Project Name: Fairgrounds Phase 3 – Perimeter Fence

Addendum No.: 1

Revised Drawings – Sheets C1.0 and C1.1 (revised 08.09.19)

FOUNDATION DETAIL
NTS

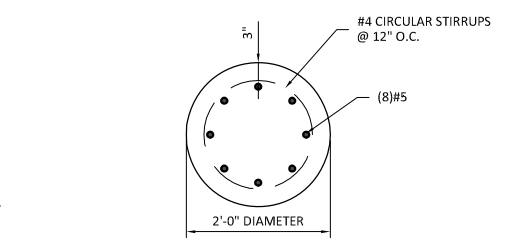
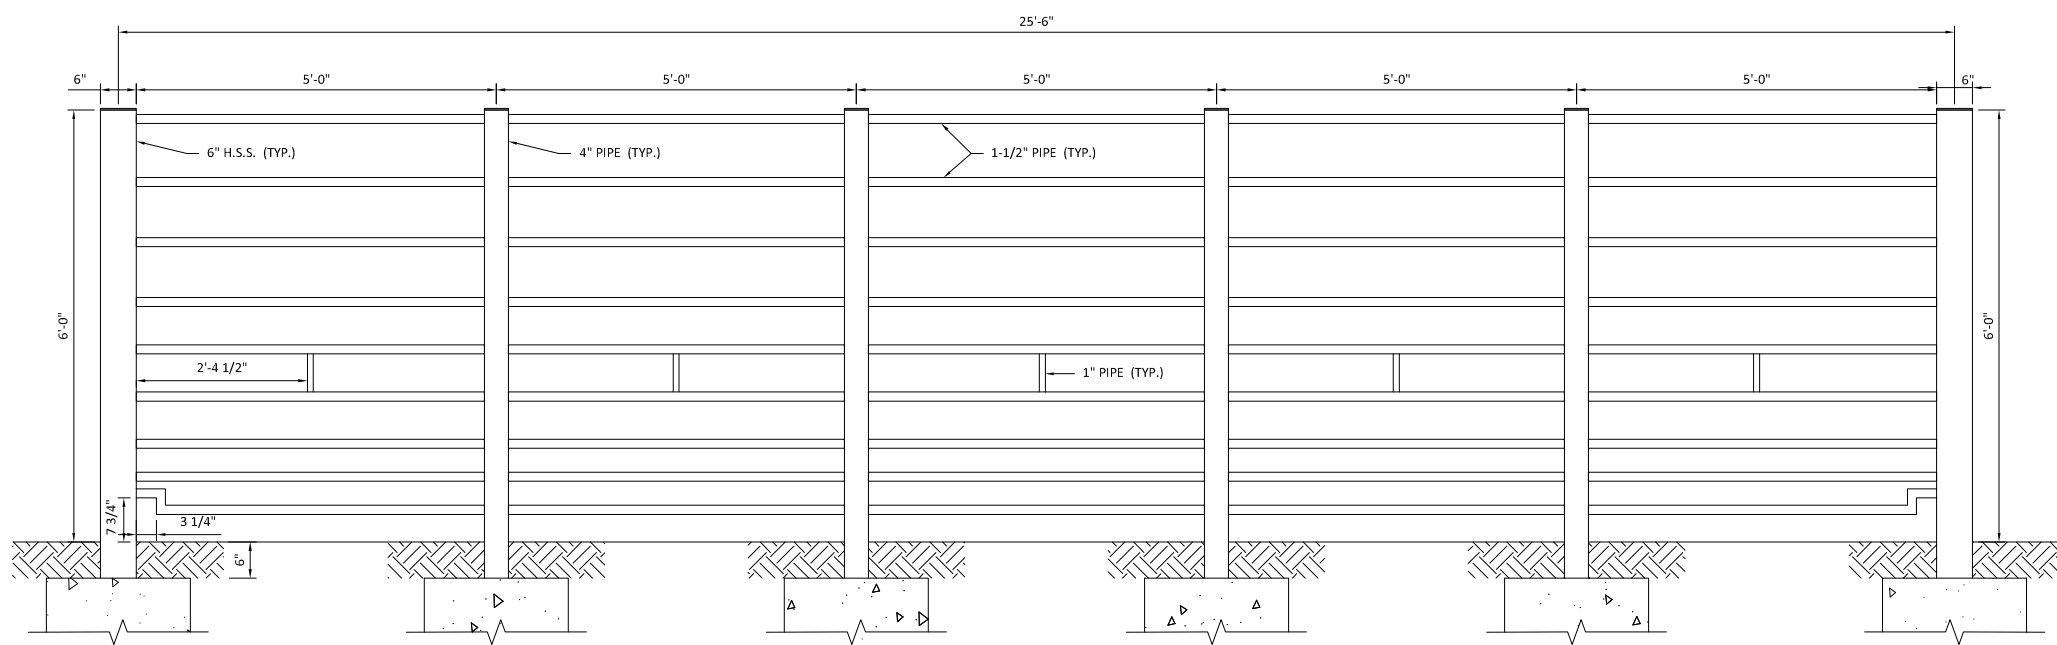
Question #1: Any rebar or wire in footings?

Answer #1: YES. SEE REVISED DRAWINGS INCLUDED WITH THIS ADDENDUM.
